Proposal for amendments to Regulation No. 46 (Devices for indirect vision)

I. Proposal

Standard Prismatic Mirror Construction (Section)

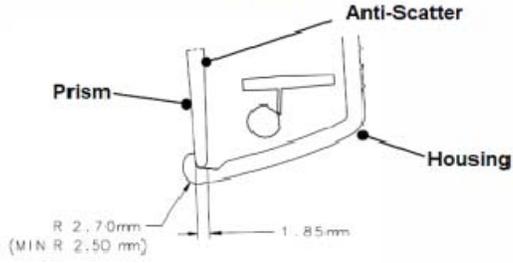
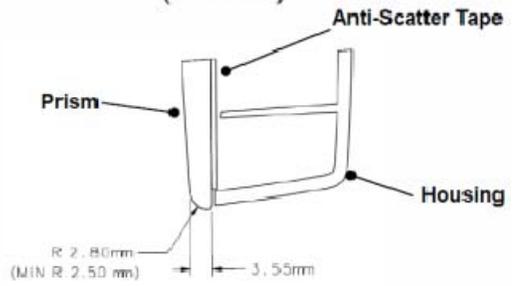
The evolution of technology nowadays makes it possible a new generation of interior rear-view mirrors having no housing or holder. This new design allows the mirror to be smaller in overall dimensions (i.e. in both width and height), leading to an improved forward Field of Vision (FOV), with no decrease in performance, while still maintaining the required rearward FOV. The current text of the Regulation No.46 unfortunately only allows for a mirror design that contains a housing (holder, etc.) which encloses the edge of the reflecting surface.

Compared to standard prisms and electro-chromatic glasses, the frameless mirror technology improves the overall glass strength and does not affect mirror reflectivity, and the lack of frame around the glass has no influence on the performance for the driver (the edge of a frameless mirror is rendered opaque by abrasion of the projecting part. Therefore only the plane mirror surface does reflect light).

"6.1.1.2. (a) **Exterior rear-view mirrors (Class II to VII)**

The edge of the reflecting surface ~~must~~ **shall** be enclosed in a protective housing (holder, etc.) which, on its perimeter, ~~must~~ **shall** have a value "c" greater than or equal to 2.5 mm at all points and in all directions. If the reflecting surface projects beyond the protective housing, the radius of curvature "c" on the edge of the projecting part ~~must~~ **shall** be not less than 2.5 mm and the reflecting surface ~~must~~ **shall** return into the protective housing under a force of 50 N applied to the point of greatest projection, relative to the protective housing, in a horizontal direction, approximately parallel to the longitudinal median plane of the vehicle.

(b) **Interior rear-view mirrors (Class I)**

In the case the edge of the reflecting surface is enclosed in a protective housing (holder, etc.), the radius of curvature "c" on its perimeter shall be not less than 2.5 mm at all points and in all directions. In the case the edge of the reflecting surface projects beyond the protective housing, this requirement shall apply to the edge of the projecting part."
